Design Advice Request

DISCUSSION MEMO

Date: December 19, 2022
To: Portland Design Commission
From: Hannah Bryant, Design & Historic Review Team
503.865.6520 | Hannah.Bryant@portlandoregon.gov
Re: EA 22-204277 DA – PSU School of Art + Design
Design Advice Request Memo – January 5, 2023

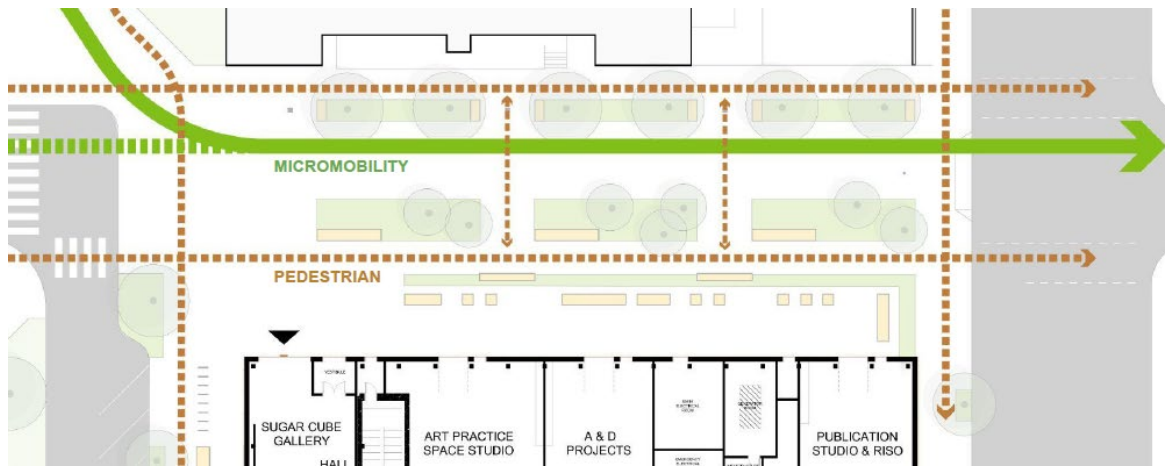
Street Frontages – This is a four-sided site, with important frontages on all sides. To the north, the Green Loop (SW College) is a very significant multimodal park; to the east is SW Broadway, to the south the Native American Community Center is across SW Jackson, and to the west are the South Park Blocks. With four important frontages, there is not an easy location for elements like services, loading and other inactive program elements.
2. **Built.** The adjacent building (the Shattuck School) on the subject site is noted as a Significant Resource in the City’s Historic Resource Inventory (HRI). This proposal does not include any changes or removal of the Shattuck School.
